Double Bay Residents' Association

10 November 2022

DA 371/2022/1 49 and 51-53 Bay Street, Double Bay

(Woollahra Development Control Plan, Chapter D5 Double Bay Centre, D5.5.8 Control drawing 4, 2015)

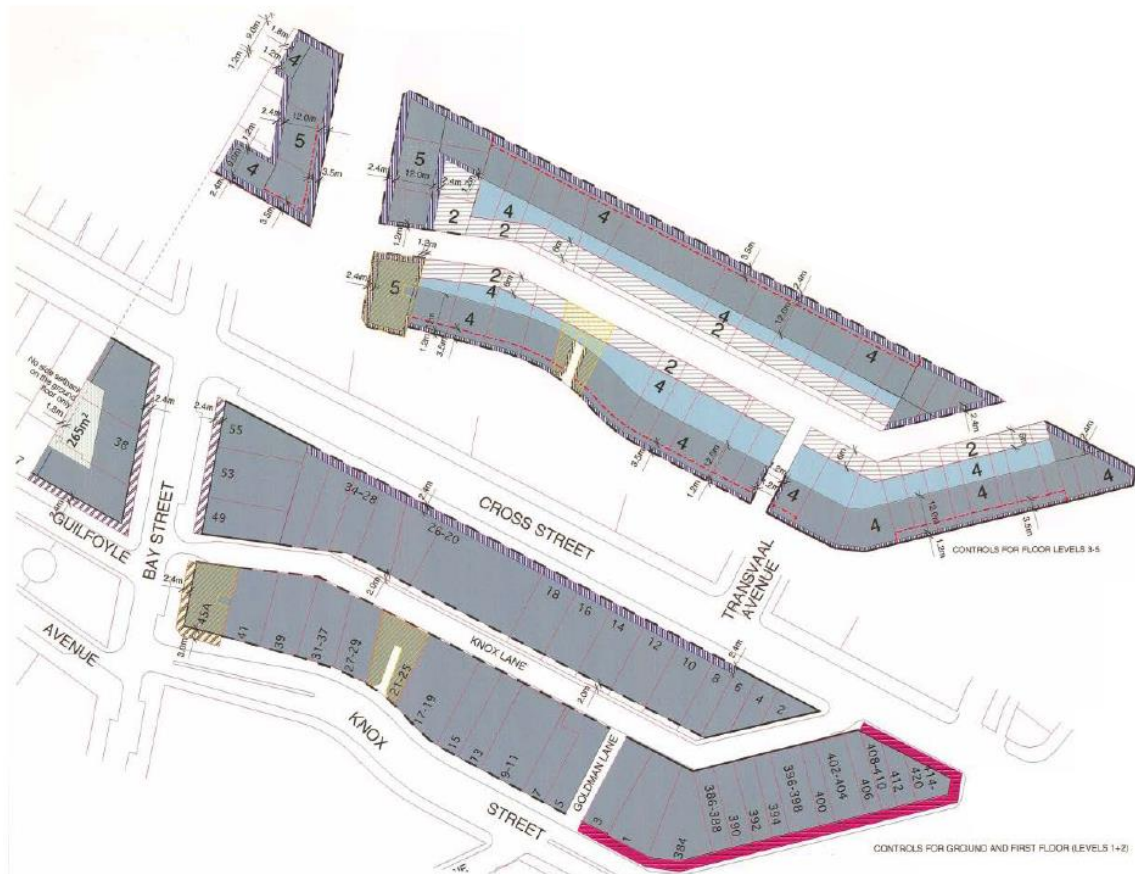
Additionally, the building envelope shown in D5.5.8 Control drawing 4 (see image below) requires that the building step down to two storeys or 8m along Knox Lane, 16.8m from the Bay Street boundary to provide an enhanced spatial definition and preserve daylight as discussed above.

As discussed, articulated areas to levels 3-5 as demonstrated by D5.5.8 Control drawing 4 have not been provided. The DCP requires a articulated area of 2.4m along Bay Street, 1.2m facing Knox Lane and 2.4m 14.4m deep from Bay Street on levels 3-5.

Image of 45A Bay Street Double Bay, (Google Maps, 2021).

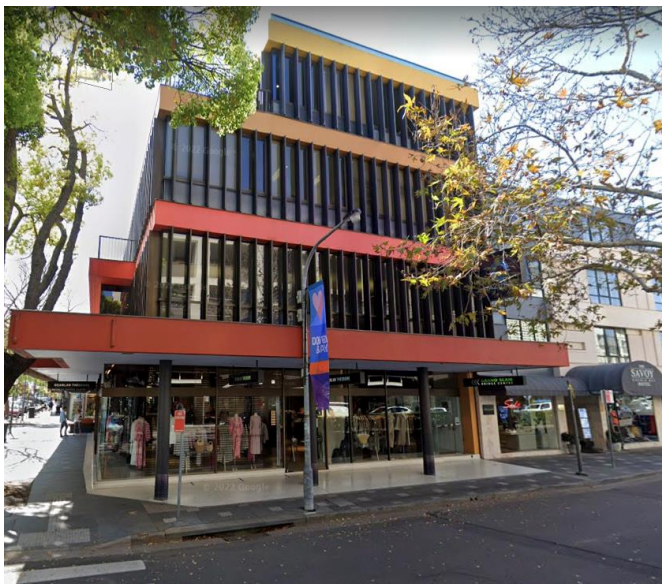
First, the adjoining 45A Bay Street to the south is a “character building” as defined in DCP 5.6.3.8. The DCP provides that character buildings along Bay Street are to be retained (see D5.4.4 at “Desired Future Character” “c”). The applicant’s attempts in their view analysis to play down the disastrous impacts their proposed development will have on outlooks from units such as 7A, 7B, 7C and 7D in the Cosmopolitan Apartments by imagining some crass future development of the 45A Bay Street site right up to the street edge should therefore be dismissed.

The four storey character building 45A Bay Street has setbacks throughout. Any development of that property, even if allowed, would have to include these qualities in their design. Therefore, even if its redevelopment were allowed its status as a character building would mean that the impact on views would be far less than indicated by the applicant.
